AMENDMENT NO. 1

**SERVICE AGREEMENT NO. 061212
WEATHERIZATION JOB ON. 308-11-03**

CHANGE ORDER

Proposed plan change to footings for Goodwin M/H

I-CODES
APPROVED FIELD COPY
GILA COUNTY COMMUNITY DEVELOPMENT
PERMIT #: P1009-047
DATE: 7/25/12 BY:

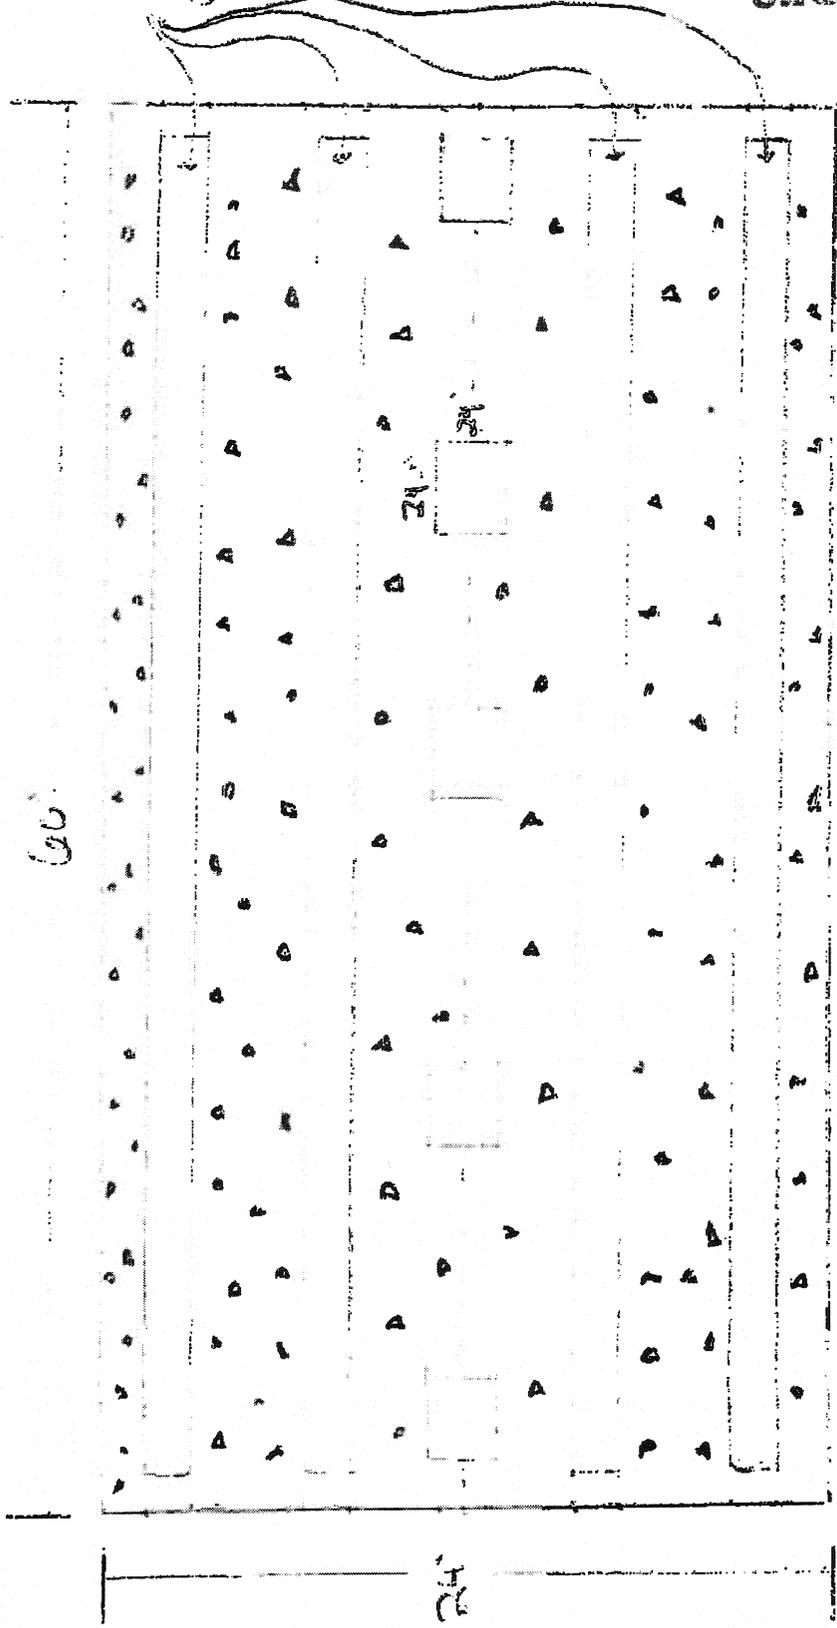
ALL MARGINS LIKE FOOTERS
 TO BE 24" X 24" X 12" DEEP
 W/ 2-#4 BARS VERTICAL

ALL FOOT CONTINUOUS FOOTERS
 TO BE 24" X 24" X 12" DEEP

3-#4 BARS
 CONCRETE
 FOOTER
 ALL FOOTERS
 12" DEEP W/
 2-#4 BARS
 CONCRETE

APPROVED FIELD COPY
 GILA COUNTY COMMUNITY DEVELOPMENT
 PERMIT #: P 1009-047
 DATE: 7/25/12 BY: [Signature]

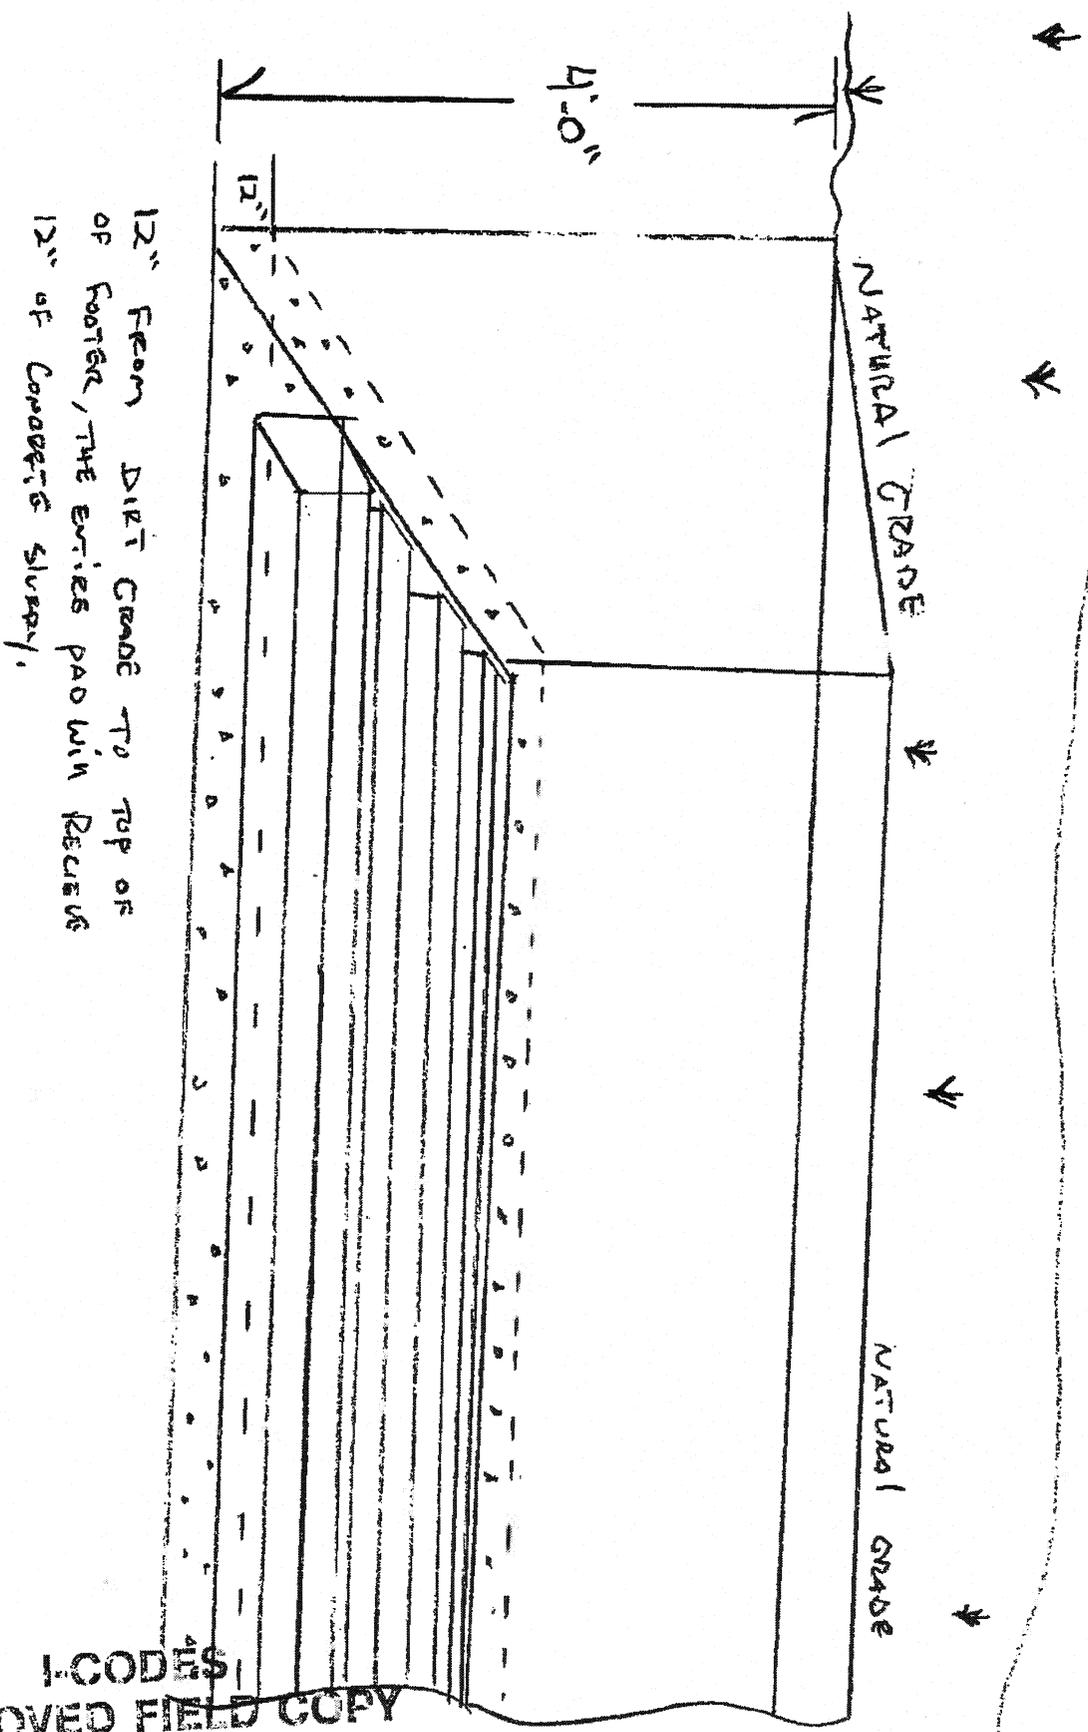
ALL APGAS OUTSIDE FOOTERS WITH
 REINFORCING 12" OF CONCRETE SURROUND
 THROUGH OUT ENTIRE PAD (60' X 24')

12" FROM DIRT GRADE TO TOP OF
OF FOOTING, THE ENTIRE PAD WITH REINFORCE
12" OF CONCRETE SLURRY.
